Ident. No. 63-34041

STATE OF IDAHO
DEPARTMENT OF WATER RESOURCES
APPLICATION FOR PERMIT
To appropriate the public waters of the State of Idaho

Re: Application for permit 63-34041

63-34041

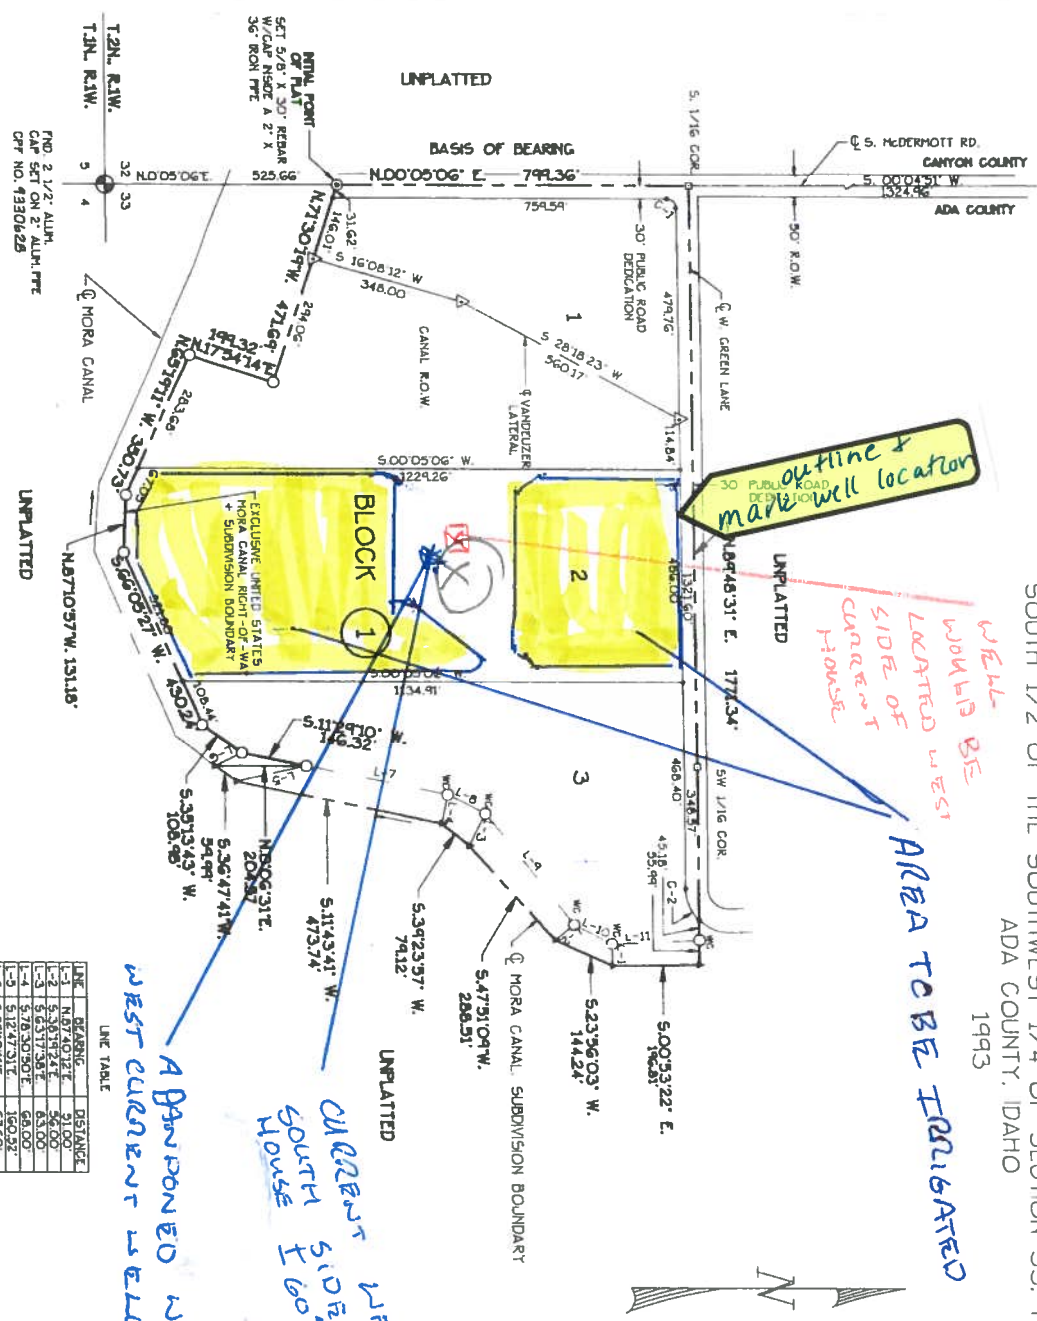
Second, section 13 of the application requires a map that clearly identifies the proposed point of diversion and place of use. Please amend your application to outline where you are planning on irrigating and using the domestic water and mark where you will drill the well.

Section 13. The copy of the original attached map has been amended to show the outlined area to be irrigated. Also, the approximate location of the proposed well is to be ± 80 feet west of current house. The domestic pump would provide all water for the residence and also a portion would be used for the landscape watering around the residence.

Existing Wells on Property. Regarding your note about other wells on the property. As far as we are aware, there is the current well we are using for domestic water (marked on the attached map with an attached well log with tag#) and an abandoned well adjacent to the existing well (also shown on the attached map with the Authorization to abandon form). We are the only ones using the existing domestic well.
